i12 (i8)

The steering column stalk switch for the turn signal sticks when actuating “headlight flasher” mode.

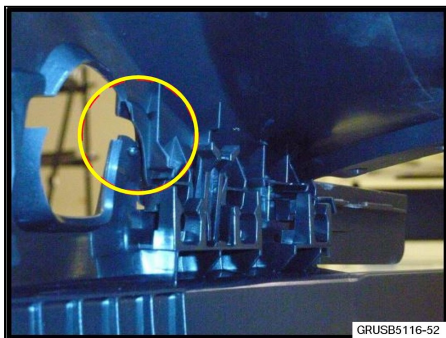
Interference fit between stalk switch and upper steering column shroud.

Modify steering column shroud.

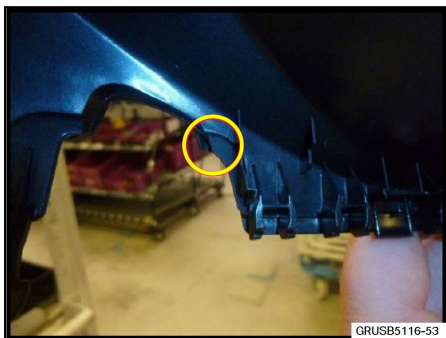
2. On the steering column shroud, rework the marked area.

Modify the marked area (approximately 5 x 5 mm) to look like the photo. Deburr and clean the worked location after material removal.

3. Reinstall the upper steering column shroud again and check that the gap to the lower steering column shroud is correct
4. Perform a functional check and ensure freedom of movement of the steering column stalk.
